4-G-21-HZ
APPLICATION FOR CERTIFICATE OF APPROPRIATENESS

404 E. Oklahoma Ave. 37917
Old North Knoxville H

Original Print Date: 4/6/2021
 Knoxville/Knox County Planning -- Historic Zoning Commission

Previous rear addition

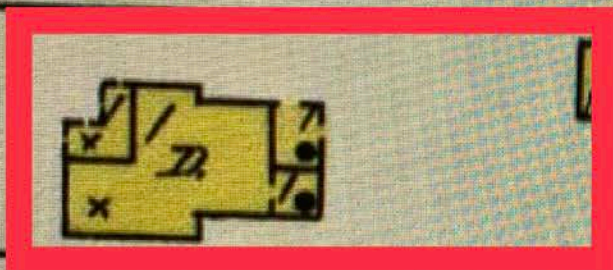
3. Citing structural concerns and non-historic materials, the applicant removed the approximately 10' long, shed-roof rear addition and reconstructed a new addition. The 1917 Sanborn Fire Insurance Map shows a footprint which reflects the previous siding details on the rear addition (see photos in application) - the rear left corner was most likely an original interior section, with the right half as a porch which was later enclosed with T-111 siding and non-historic windows.

Photos of the previous rear addition show a small (under 1 foot) inset on the house's right side. The addition has now been constructed flush with the primary residence, with a flat roofline continuing from the primary hipped roofline.

The Commission should discuss whether the new rear addition is sufficiently differentiated from the primary house, and what other tactics the applicant may take to differentiate the new addition from the original house. At minimum, the applicant should incorporate wood cornerboards (vertical trim piece) to differentiate the new addition from the primary house. The rear addition should also feature an additional window on the left side of the rear elevation, which is currently a large expanse of siding with no transparency. The Commission may choose further recommendations regarding the rear addition to meet the "additions" section of the design guidelines.

The Commission should discuss the current rear addition's differentiation from the original house. At minimum, staff recommends the installation of vertical trim mimicking cornerboards to separate the two massings, and the installation of an additional one-over-one, double-hung wood window on the left side of the rear elevation.

OPTION 1

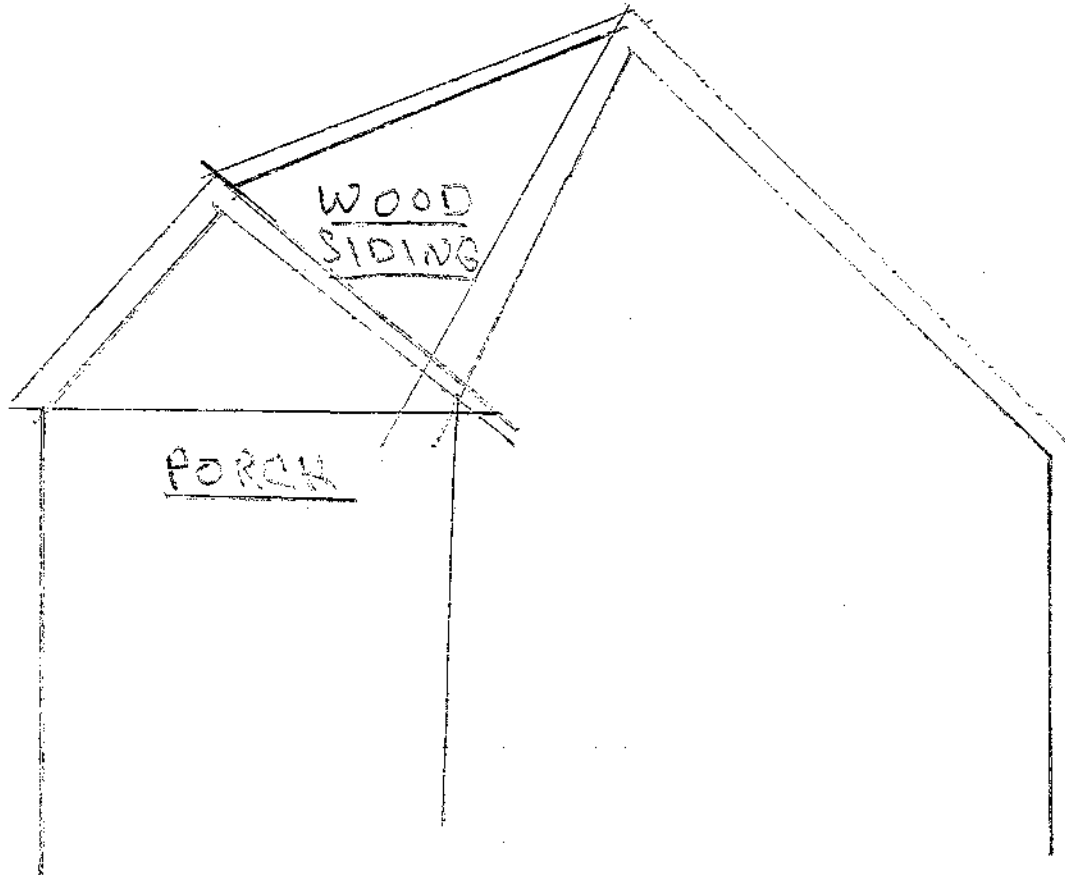
4. The roofline modification as completed (proposed as Option 1) does not meet the design guidelines and should be removed. The house is a Folk Victorian, with numerous comparable designs in the block and neighborhood. The 1917 Sanborn Fire Insurance Map shows the porch's original footprint, which was an L-shaped corner porch. Similar houses in the neighborhood feature low-pitch hipped or shed rooflines. The front-gable roof porch, projecting approximately 1' out from the primary house, was a non-historic modification. The front-gable porch roof intersects with the main front-gable roof and creates a flat section without drainage, contributing to roof leaks and deterioration. The small, non-draining section at the roofline intersection is the element the applicant aims to mitigate.

Staff recommends removal of the unpermitted roofline modifications and postponement of the review of further modifications to the roofline to allow for further information to be presented to the Commission.

OPTION 2

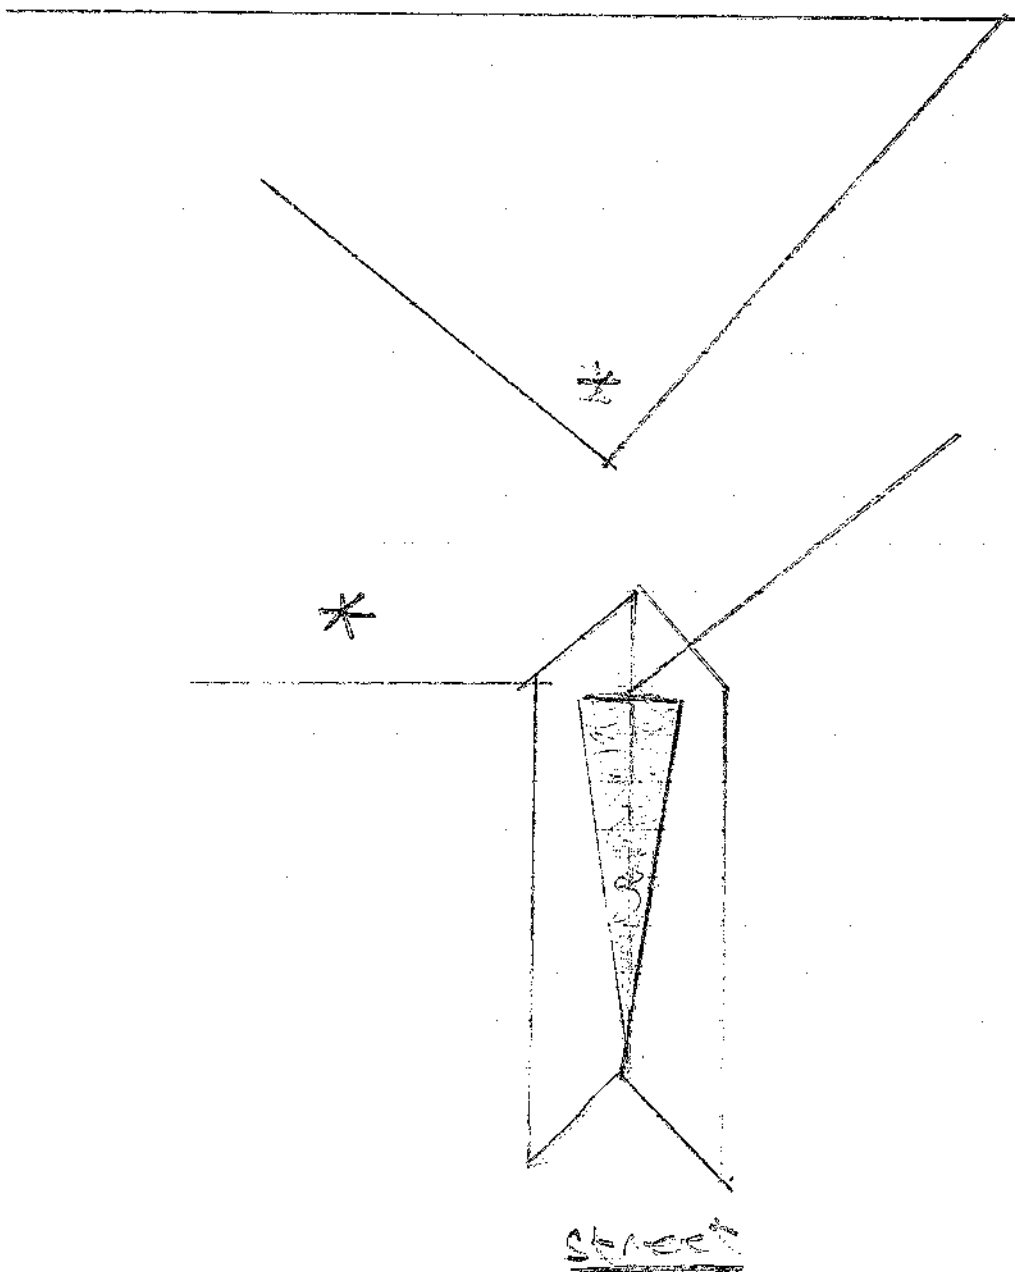
Further information on Option 2 is needed, including specifications of the "iceshield" element and a rendering showing that the new element and shingles would not be visible from the street.
